Stonehouse – Legends Golf Course

From: Scott Thomas
Sent: Thursday, February 07, 2002 3:43 PM
To: Darryl Cook; Joan Etchberger; Gerry Lewis
Cc: Pat Menichino
Subject: Stonehouse Legends Golf Course

RE: Case No. SP-92-94, Legends at Stonehouse Golf Course

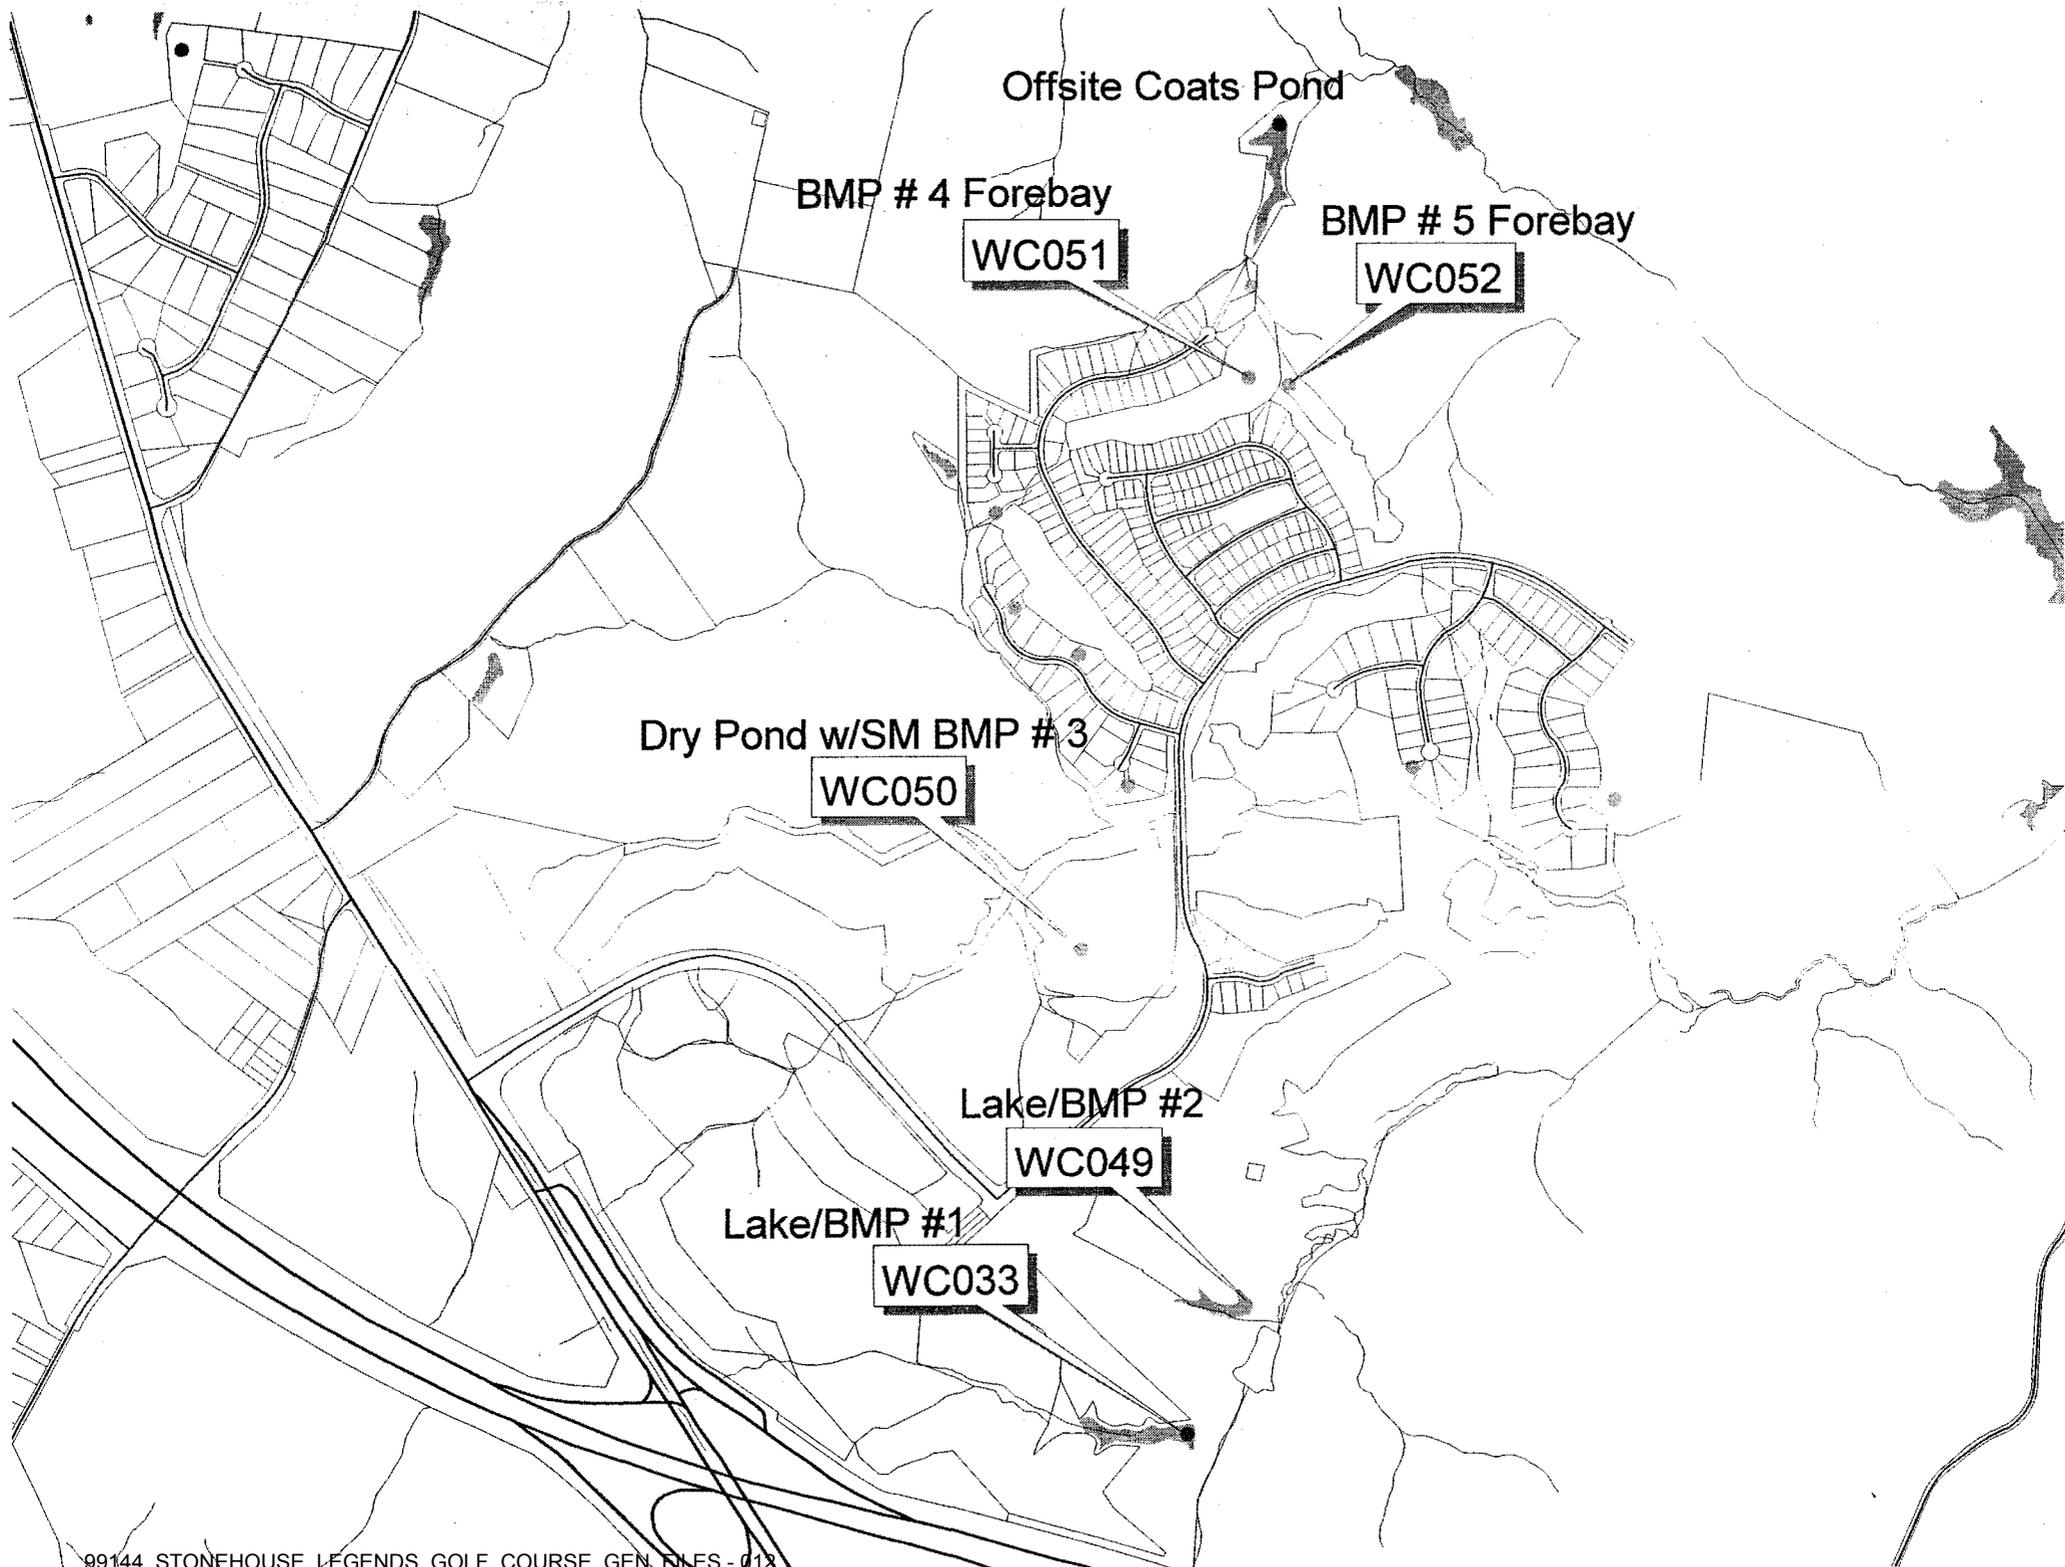
I have probed and sifted through the Legends of Stonehouse Golf Course files, which were slated for closeout. Joan had drafted a letter (but not sent) authorizing release of \$ 25,000 for erosion and sediment control bond being held for the project. This golf course, the maintenance facility, and the clubhouse are inclusive to this plan.

The original project plan for the Legends at Stonehouse Golf Course was approved as SP-92-94. This plan showed 5 BMPs for the project as a whole. The list is as follows:

Based on what I see, the original plan SP-92-94 required as-built drawings for all detention facilities. Note # 21 on Sheet 20 of the approved plan has a note which required the as-builts. In addition, under our division's review of SP-92-94, Comment # 3 stated "As-built drawings must be provided for detention facilities upon completion". For BMP # 2 and BMP # 3 which were constructed in subsequent plan SP-34-95 for the Maintenance facility, a newer version of the note was present. Note # 18 on Sheet 5 required both as-builts and construction certification.

In summary, BMPs # 1, # 4 and # 5 required as-builts only. BMPs # 2 and # 3 required as-builts and construction certification. I have searched all our possible places in the active and as-built files and do not see where any of these were provided. Per my usual review process, the normal would be to notify the owner that we cannot proceed with release of the bond until the as-builts and construction certifications as such are reviewed and approved.
